**WALKTHRU BUILDING PERMIT**  
 BP# B0157520A# 49655  
 APP. SAN Kelce Neenan DATE: 1/3/06  
 DESC. OF WORK: large pool  
Site isp done by SANDTARIAN

**LOT 707  
BURLEIGH MANOR**

**SITE PLAN**

SITE INSPECTION SHEET

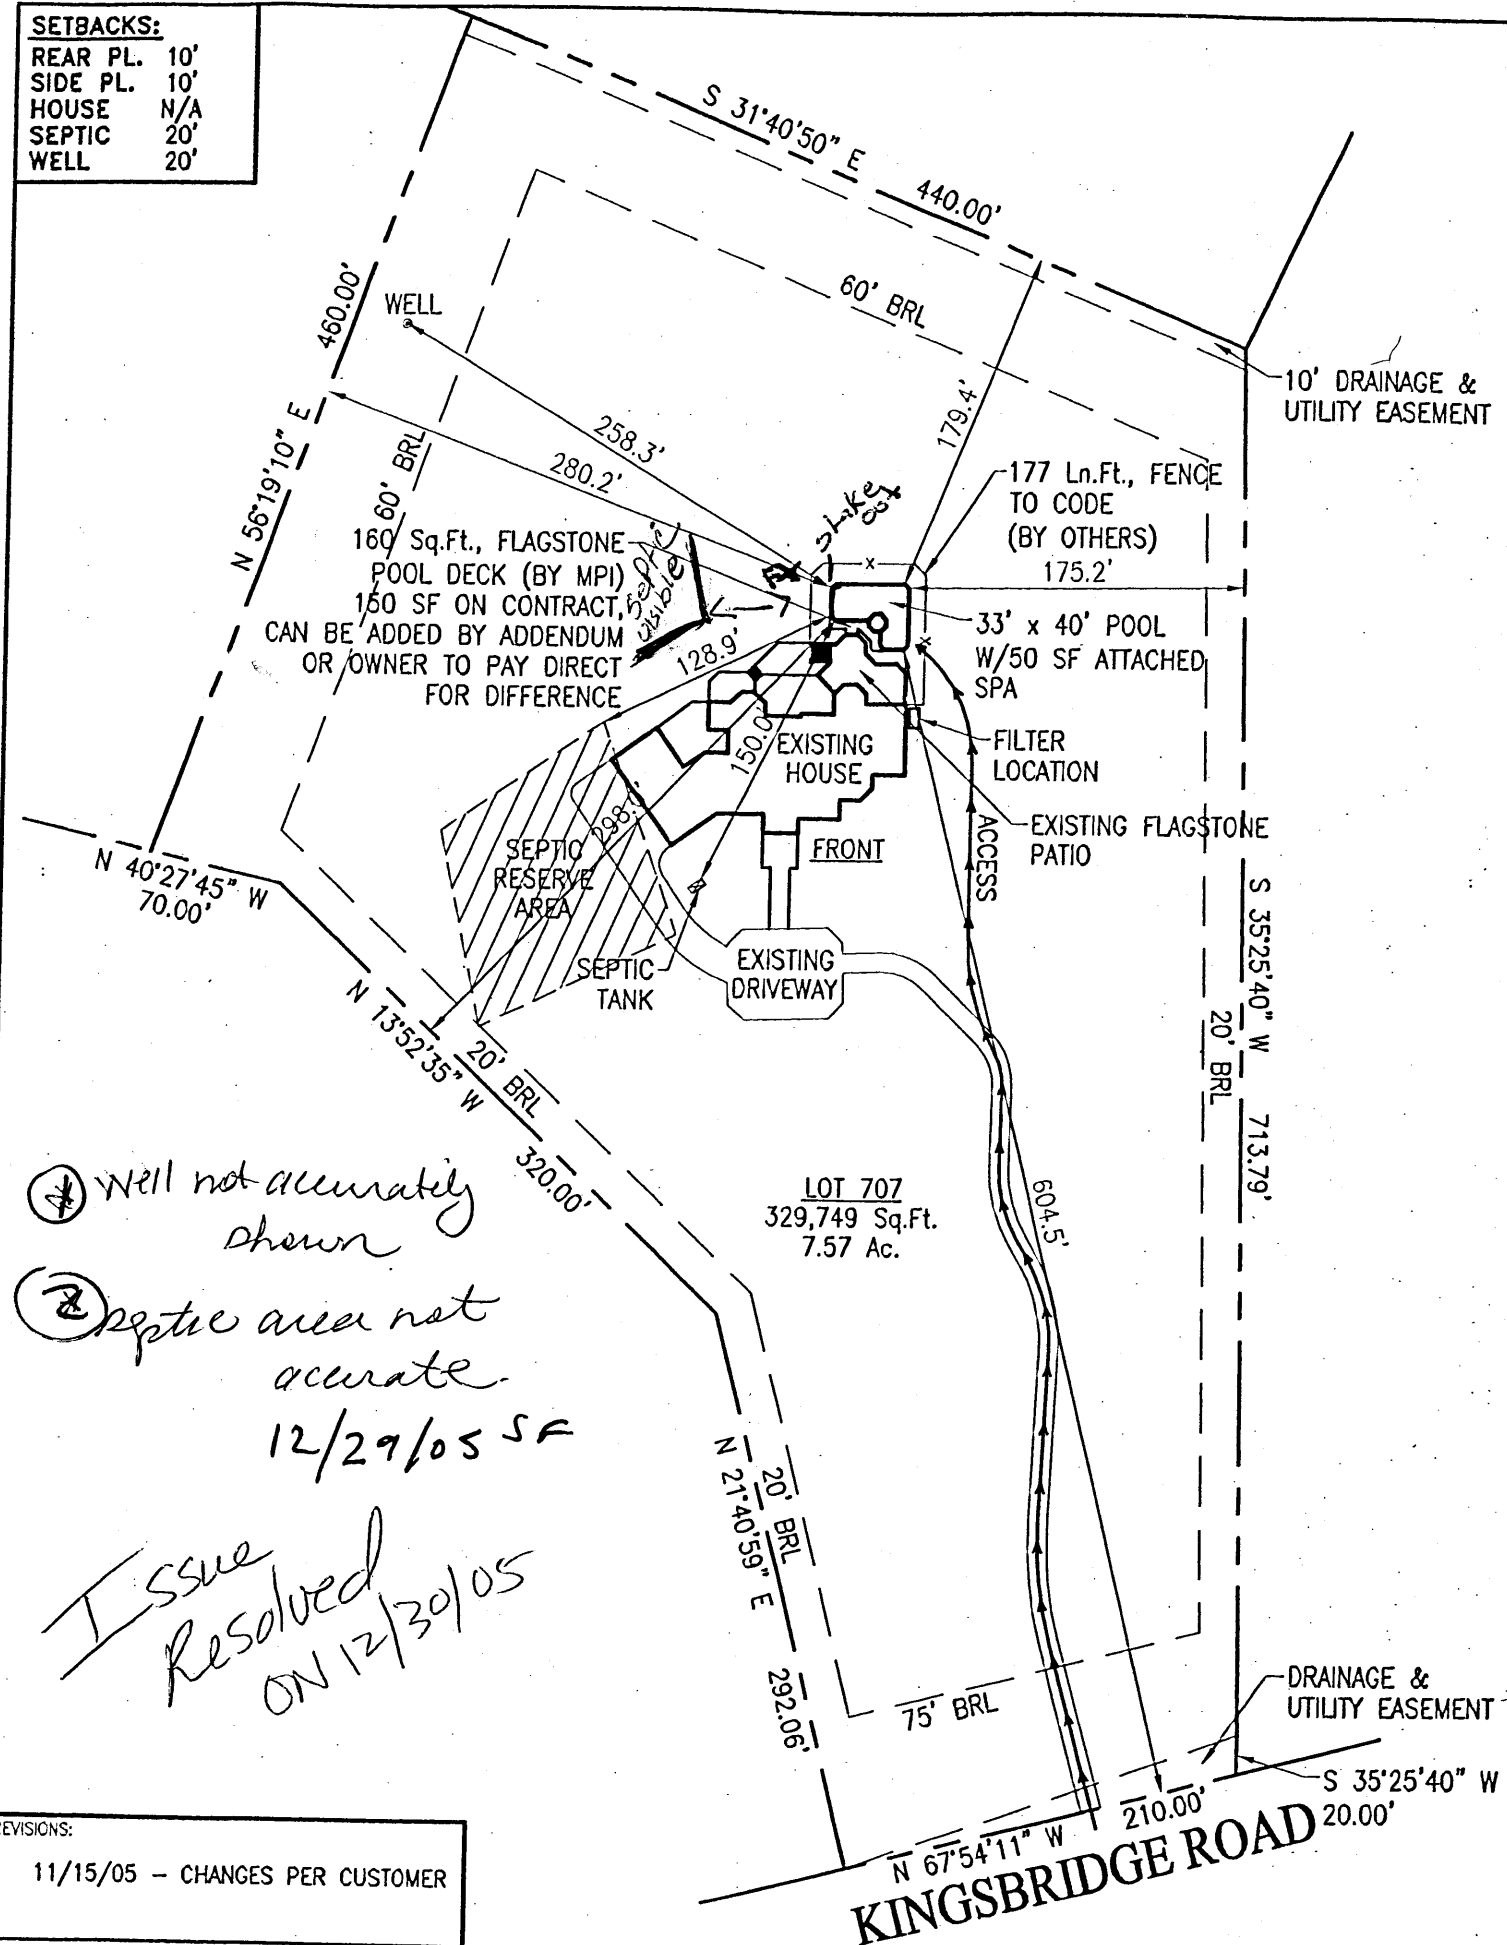
Well not accurately shown  
 Septic area not accurate  
 12/29/05 SF  
 Issue Resolved ON 12/30/05

LOCATION DIAGRAM

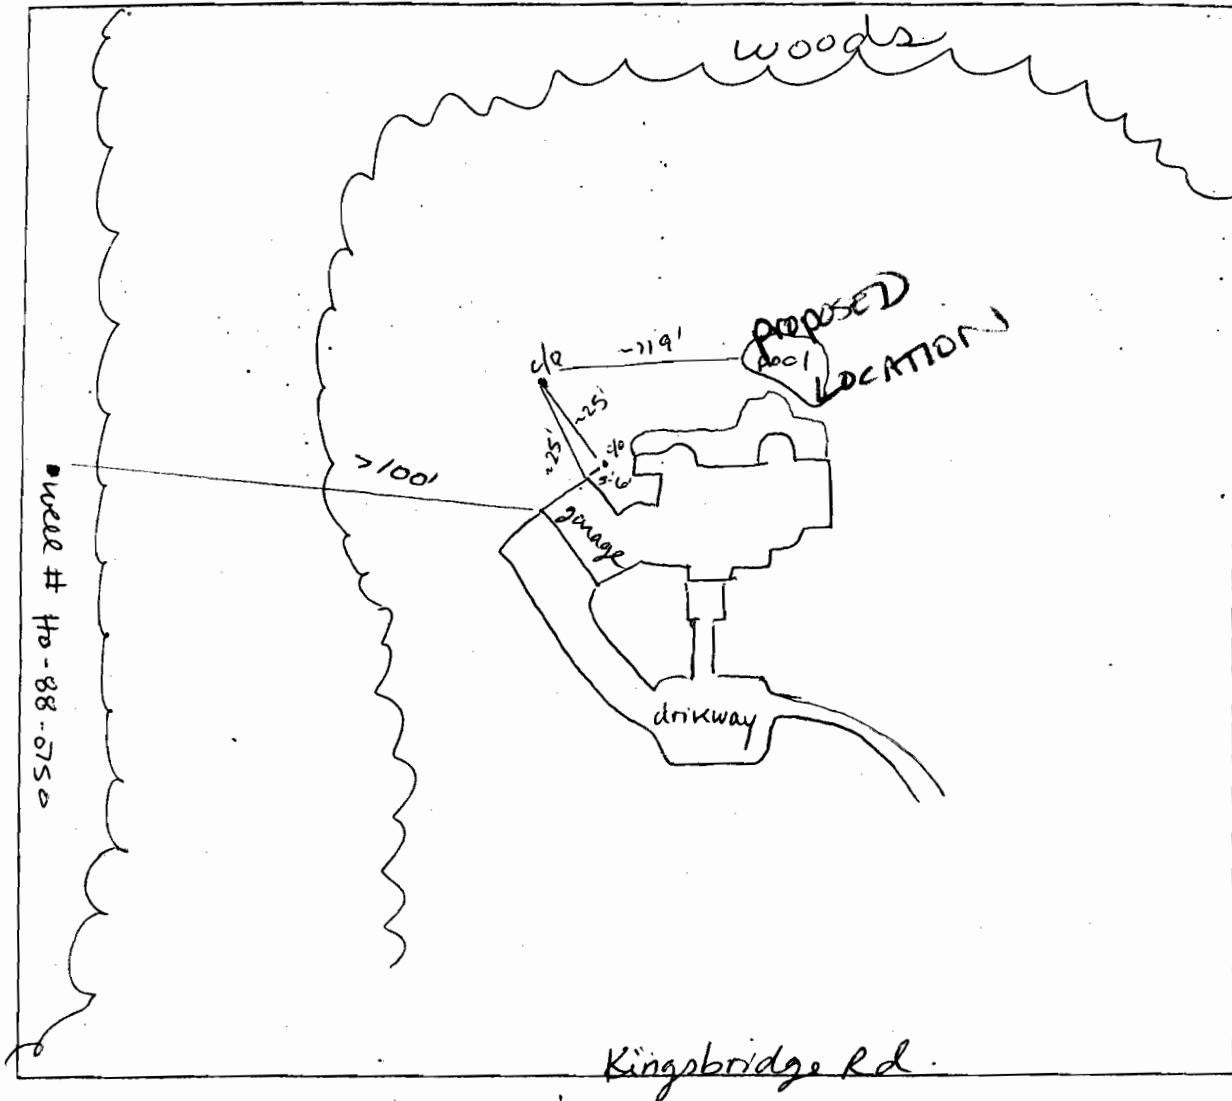
Verify pool location and distance from septic

COMMENTS: Pool adequate distance away from septic and well. well located just along tree line ~ 8' above grade.  
1/3/06 KN Signs pool permit
